MCK ARCHITECTS STUDIO 401, 104 COMMONWEALTH STREET SURRY HILLS NSW 2010 TEL 02 9211 4146	PROPOSED APARTMENTS AT 5 BAY VIEW STREET LAVENDER BAY FOR YOLANDA CAMUGLIA	COVER SHEET	0 1 2 3 4 5 6 7 8 9 10	SKC
			27 AUGUST 2021	
		DRAWN - MC	JOB NO. 1911

MCK ARCHITECTS STUDIO 401, 104 COMMONWEALTH STREET SURRY HILLS NSW 2010 TEL 02 9211 4146		PROPOSED APARTMENTS AT 5 BAY VIEW STREET LAVENDER BAY FOR YOLANDA CAMUGLIA		LEVEL 0 PLAN				SK00
				1:200 @ A3; 1:100 @ A1		27 AUGUST 2021		
				DRAWN - MC		JOB NO. 1911

PROJECT
CAMUGLIA
5 BAY VIEW STREET LAVENDER BAY
NORTH SYDNEY NSW 2060

MCK ARCHITECTS STUDIO 401, 104 COMMONWEALTH STREET SURRY HILLS NSW 2010 TEL 02 9211 4146	PROPOSED APARTMENTS AT 5 BAY VIEW STREET LAVENDER BAY FOR YOLANDA CAMUGLIA	SECTION C-C	0 1 2 3 4 5 6 7 8 9 10	SK12
		1:200 @ A3; 1:100 @ A1	27 AUGUST 2021	
		DRAWN - MC	JOB NO. 1911

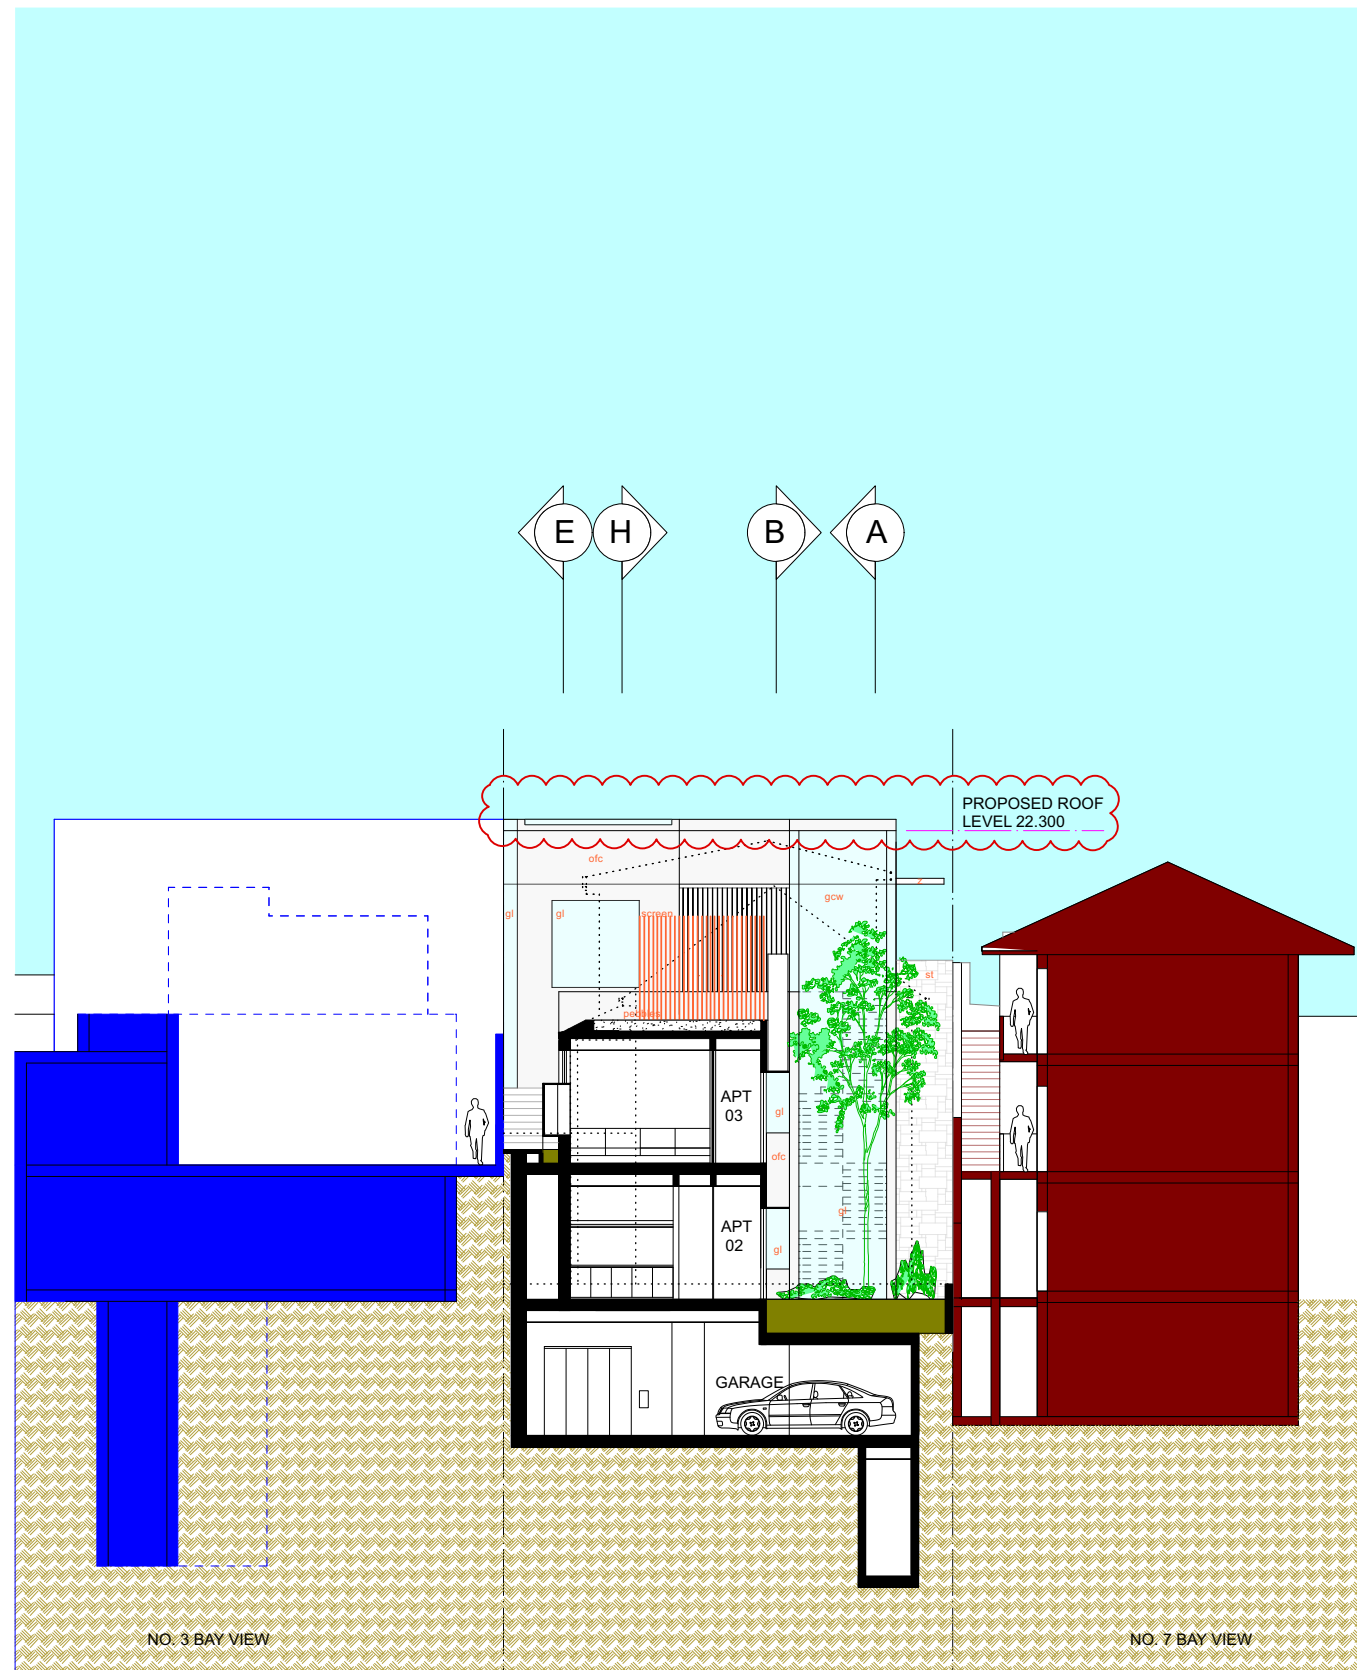
Relocation of storage room to Level 0 from Level 1
